## Accessibility Survey

### City of Downey De Palma Street - Downey Avenue To Paramount Boulevard

Alameda Street  
Downey, CA 90242

Date of Inspection  
1/31/2017

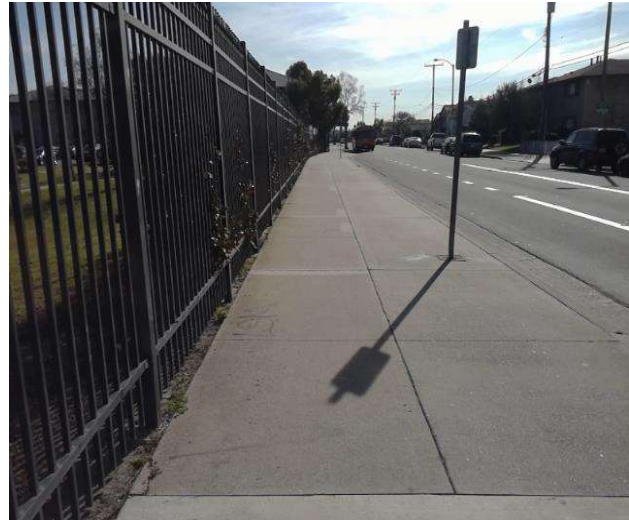
Sidewalk cross slope is not compliant.

**On-Site Finding** 3.50 percent for 360.00 feet

Repave the sidewalk surface with the recommended cross slope.

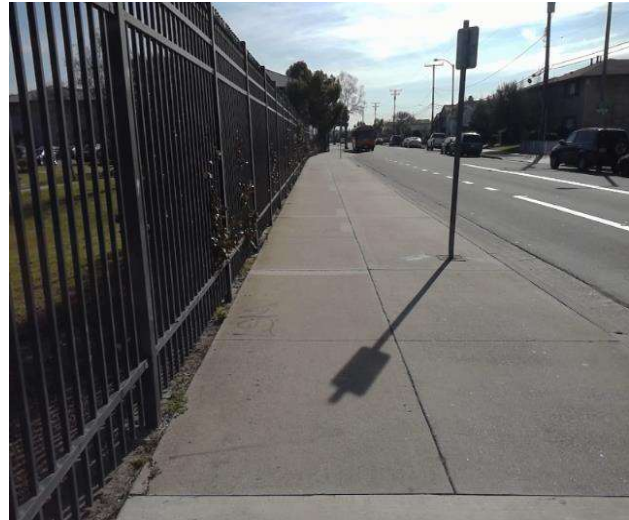
Ground surface has an opening that is not compliant.

**On-Site Finding** Not Compliant

Make sure that the surface opening does not allow passage of a sphere more than 1/2 inch in diameter.

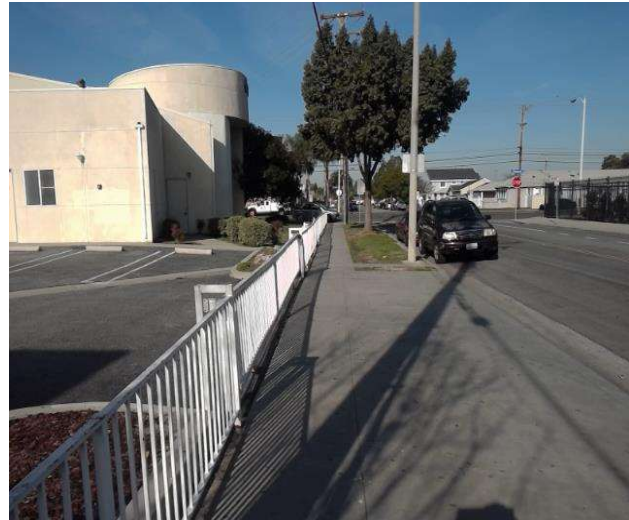
There are no detectable warnings where the pedestrian route crosses vehicular traffic.

**On-Site Finding** Not Found

Provide detectable warnings.

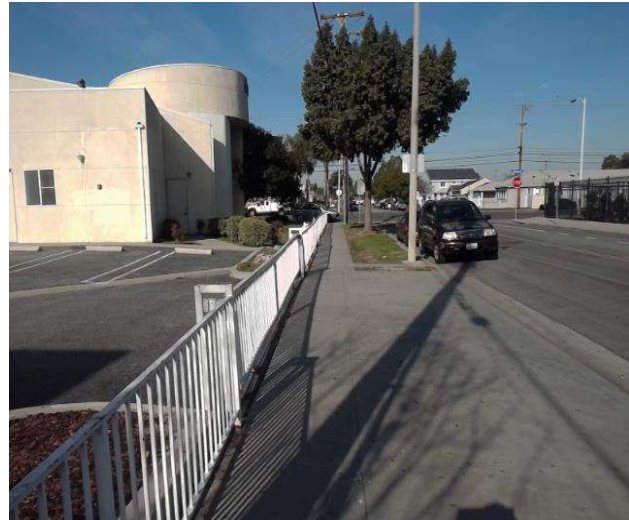
Cross slope at vehicular traffic is not compliant.

**On-Site Finding** 5.50 percent

Repave the surface to provide a compliant cross slope.

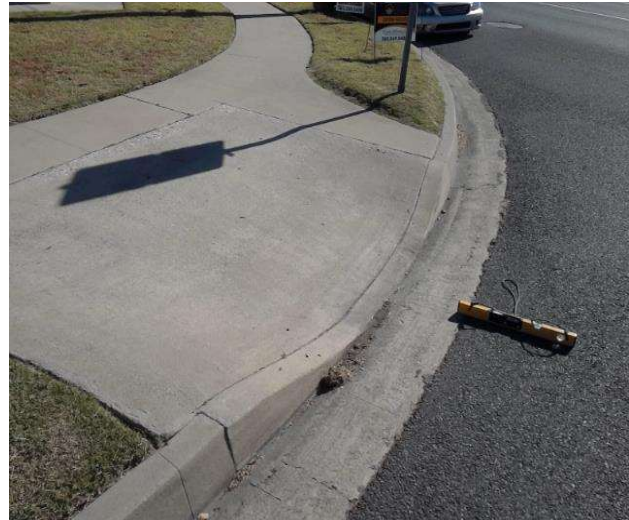
**On-Site Finding** 34.00 inches

Provide a level top landing with enough clear length.

Recommendation At least 48.00 inches

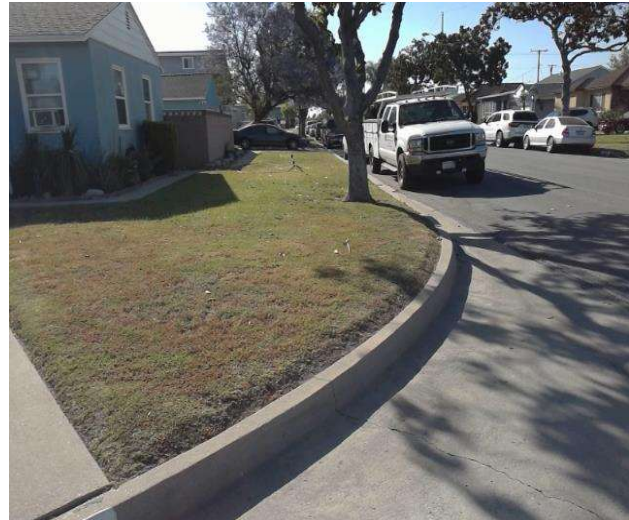
Section of sidewalk is missing and consists of dirt, grass or gravel.

**On-Site Finding** 156.00 feet

Provide a compliant sidewalk for the missing section.

**Change In Level East Of Mitla Avenue @ 33.943366621980, -118.157120794058**

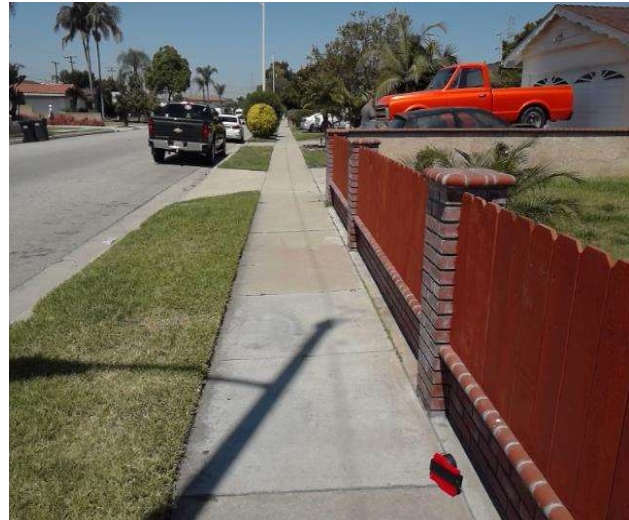
There is a change in elevation greater than recommended value.

**On-Site Finding** 0.50 inches

Ensure that the change in elevation is within the recommended value.

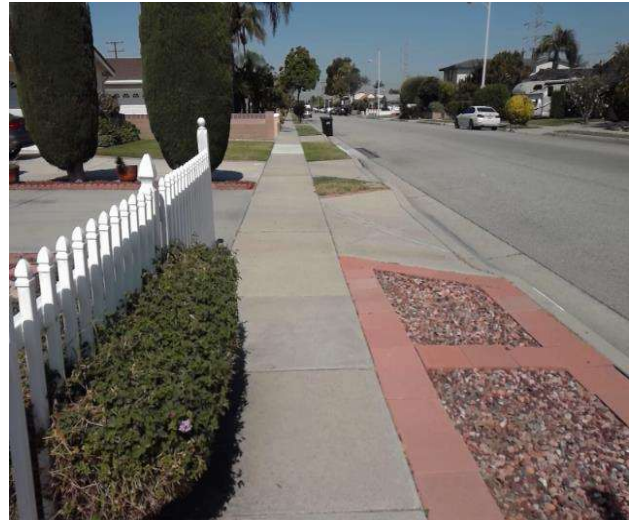
Sidewalk width at the obstruction is not compliant.

**On-Site Finding** 32.00 inches

Sidewalk width at the obstruction shall have the recommended value.
